# DEVIATION REQUEST AND DECISION FORM

Project Name : The Glen at Widefield Filing No. 11  
 Schedule No.(s) : 5522000009, 5522000007  
 Legal Description : See Attached Document

A deviation from the standards of or in Section **ECM 2.3.3.F.3** of the Engineering Criteria Manual (ECM) is requested.

EXHIBIT 1

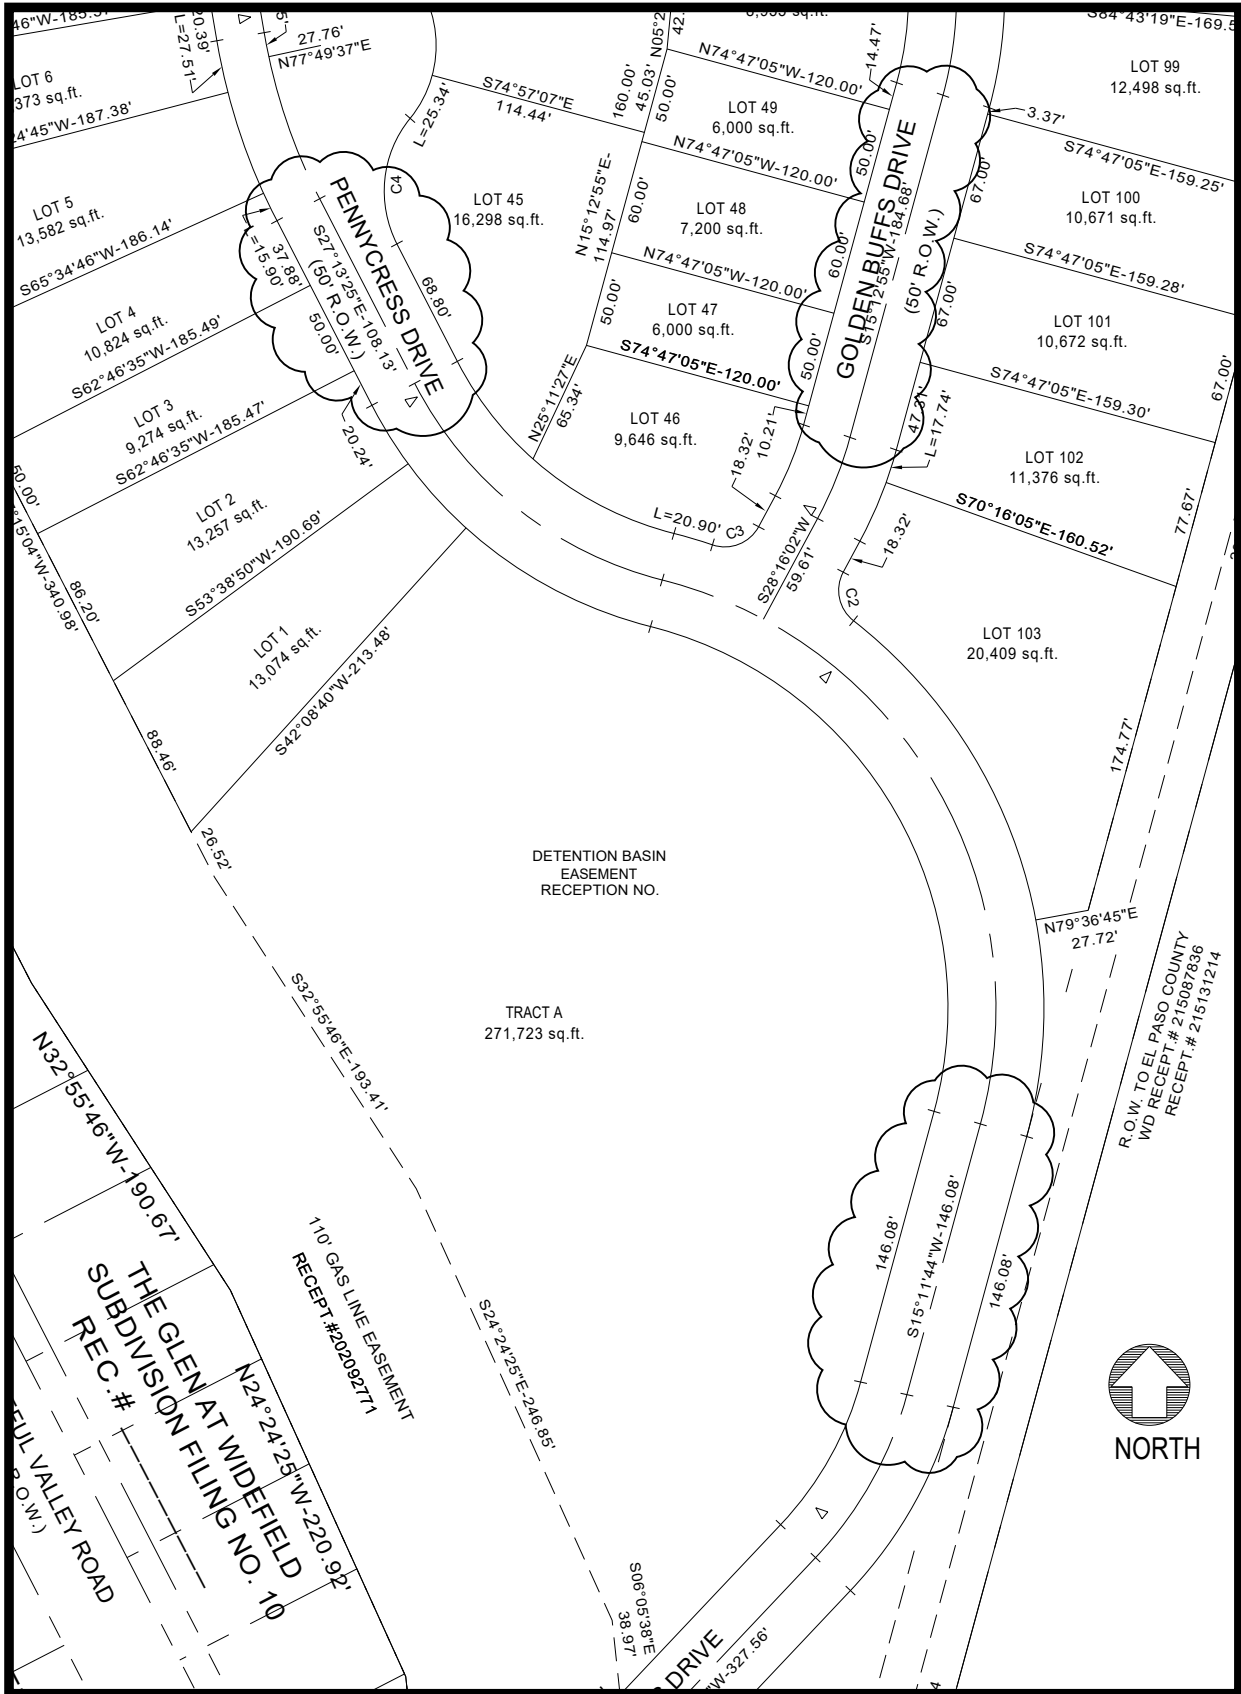
The Deviation is requested in the three locations shown on the plat. Two locations on Pennycress Drive in the south end of the subdivision and the third is on Golden Buffs Drive near the intersection of Pennycress Drive. This section of the plat has a constricted geographic triangular shape due to an existing large gas line which converges with the Marksheffel Road Right-of-Way. The tangent sections are less than 200 feet, but they were laid out in order to make the streets and lots in this area as efficient as possible and in the case of the Golden Bluffs Drive section the tangent section is shorter so that a horizontal curve can be provided at the south end that allows the intersection of Pennycress Drive and Golden Bluffs Drive to be 90 degrees, thus avoiding a non-radial intersection. In order to lengthen the tangent sections along Pennycress Drive we would need to tighten the horizontal curve radii which would make the drivability less than ideal. In cases where we could increase the curve lengths to create a large sweeping reverse curve there is a possibility that we would make the adjacent lots unbuildable.

The current design as submitted with the broken back curves occur on low traffic volume local streets. We have used the same types of curve and street geometry throughout the City of Colorado Springs and they are allowed, approved and function safely and adequately throughout the City. The lengths of the tangents on the three locations are as follows. The two sections on Pennycress Drive are 108.13' and 146.08'. The section on Golden Bluffs is 184.68'. These distances are below the 200' minimum as specified in the ECM standards. Please refer to Exhibit 1 attached to this document.

The geographic shape and topographic nature of the area of the subdivision in question is such that the use of longer tangent sections and tightening of the horizontal curve radii would promote a less aesthetic design of lots and street system. The use of the shorter tangents while utilizing less than the minimum curve radii will not compromise safety or accessibility. The shorter tangent sections allow the efficient design of both streets and lots in this constricted location.

This request has been determined to have met the criteria for approval. A deviation from Section 2.3.3.F.3 of the ECM is hereby granted based on the justification provided.
